**WOKINGHAM
BOROUGH COUNCIL**

Outline Planning Approval Consultation

Application Number: 250517

MEMORANDUM

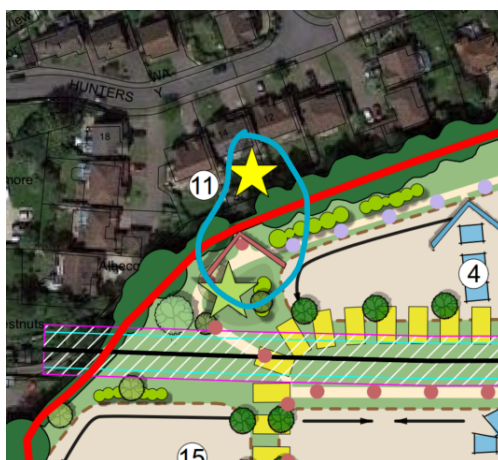
- i) From a green infrastructure perspective, the connection to PRoW Shin33 is a desirable link and should be pursued in line with Policy CC03. If this is an acceptable connection from a PRoW and Highways perspective, details of the connection will need to be provided.
- ii) I question the proposed pedestrian/ cycle connection to Barracks Lane shown at the northwest corner of the scheme. I appreciate the attempt to increase permeability and links to points outside of the development. I defer to Highways to comment if this can be accomplished safely considering Barracks Lane appears to be a very narrow lane that is fenced on the north side except where it connects to adjacent dwellings.

- iii) I again appreciate the attempt to increase links and permeability to points outside of the site. The proposed access point at the northeast edge of

the scheme is meant to provide connection to an off-site playground and Century Drive. Century Drive then provides further access to Hyde End Road. However, details of the access will need to be considered as there will likely be landscape and possibly ecology impacts with the removal of G59 vegetation to accommodate the footpath.

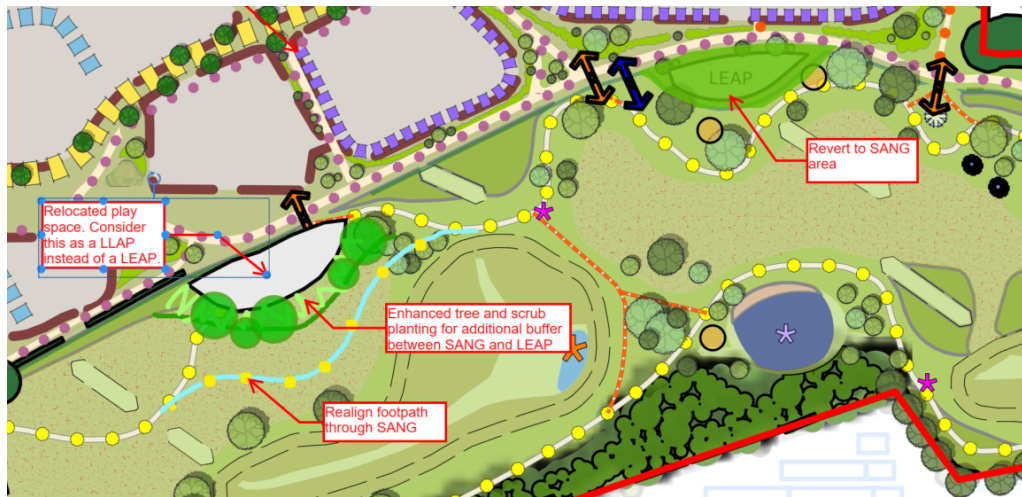
- (2) I have a concern that the LEAP in the northeast area of the scheme is very close to the footpath within the SANG and that this may have an urbanising impact on the SANG. Being mindful of the Exolum pipeline

and easement, can a new location for the LEAP be considered, as shown below? A LEAP in this location is somewhat more central to the northern residential plots and still within a comfortable walking distance. It also allows for more opportunities for a landscape buffer/screen to be provided between the LEAP and the footpath within the SANG. If the LEAP is not relocated, I would encourage more separation between the LEAP and the proposed footpath within the SANG.

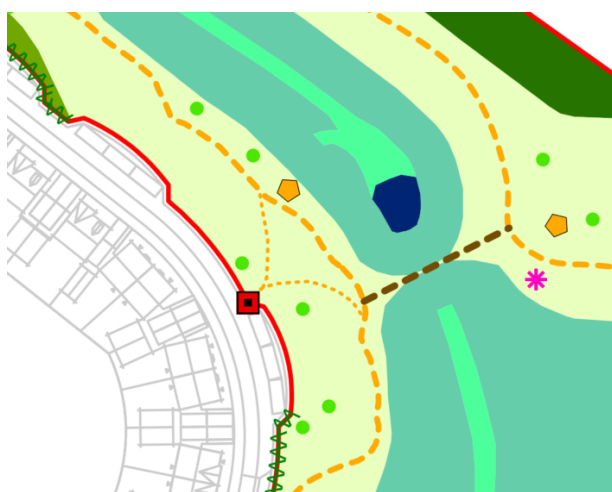
- i) Natural England, in their 4 March 2026 Planning Consultation response, has noted, and I concur, that there is the potential for an urbanised feel along the western portion of the SANG that needs to be addressed.

As seen in the screen grab taken from the most recently submitted Illustrative Landscape Master Plan (P23-2449_EN_C_ILMP), there will be two visitor parking bays with approx. 3 spaces each, a secondary route for vehicles, and a footpath before reaching the residential units. Within

this area, limited, if any, vegetation is shown for screening the vehicles from the SANG footpath. The road, visitor parking, footpath, and the 2-storey residential units and associated parking with limited screening will all contribute to this feeling like an urbanised edge, out of character with the objectives of a SANG.

This is further illustrated in Figure 2b of the SANG General Arrangement Plan that area provided in the EPR SANG Creation and Management Plan (3336-1E, dated 06 February 2026) and the sections.

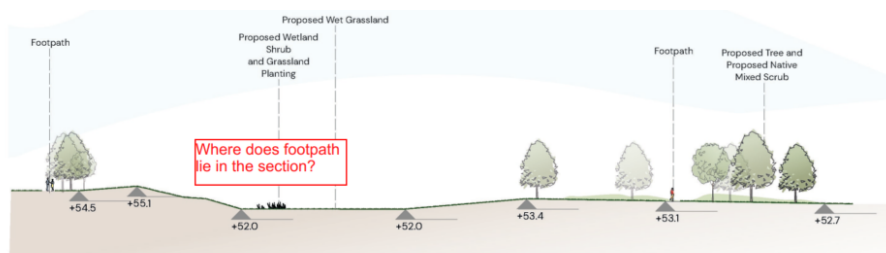
- ii) There are discrepancies between the SANG footpath alignment shown on the Illustrative Master Plan (P23-2449_EN_C_ILMP) and the SANG General Arrangement Plans in the EPR document. In the screen grab below from the GAs, the western footpath appears to be close to the attenuation pond whereas the alignment in the illustrative master plan shows the footpath closer to the western SANG boundary. This discrepancy is also shown in Section AA' of the sections that have been provided (P23-2449_EN_0014_0001).

I am interested to see where the footpath is located in this part of the SANG. A footpath location further to the east may lessen my concerns as it appears that this could allow for a

footpath that is further from an urbanised edge, potentially down slope, and with more options for a planting that could serve as a screen.

Please confirm the location of the footpath along the western boundary of the SANG. If the location of the footpath changes, please also confirm that length is still at least 2.3km.

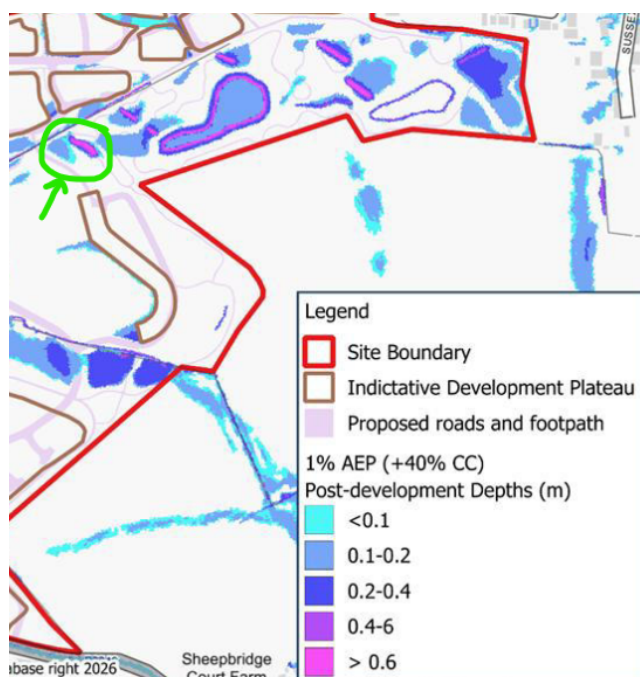
- (1) Natural England has previously commented highlighting concerns about how footpaths around the year-round accessibility of footpaths in low-lying areas of the site. As an updated FRA has been provided, Natural England should provide feedback on whether their concerns have been addressed.
- (2) It does not appear that an updated drainage note (RACE) has been provided. Previous comments have highlighted that there are existing foul water lines and associated easements that run through the SANG. It is unclear how these lines and easements are addressed with the current design and if there will be any impacts on planting and buffers within the SANG.

Similarly, it is unclear if any new drainage or foul water lines will be required to service the development.

Please provide a plan showing proposed and existing drainage and foul water lines to remain which run through the proposed SANG. This should also show any associated easements.

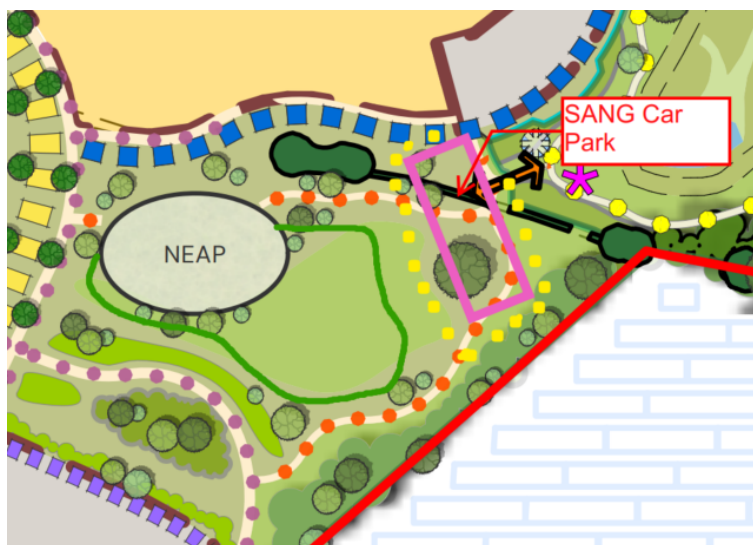
(8) A plan that addresses the delivery of the SANG car park must be provided. Without a delivery plan, it is difficult to know when the car park should be delivered. If areas of the development fall outside of the 400m distance, the car park should be delivered at the same time as the SANG, prior to first occupation.

However, if the entirety of the development falls within the 400m area and the SANG is accessible by footpath, it is possible that the car park could be delivered at a later point.
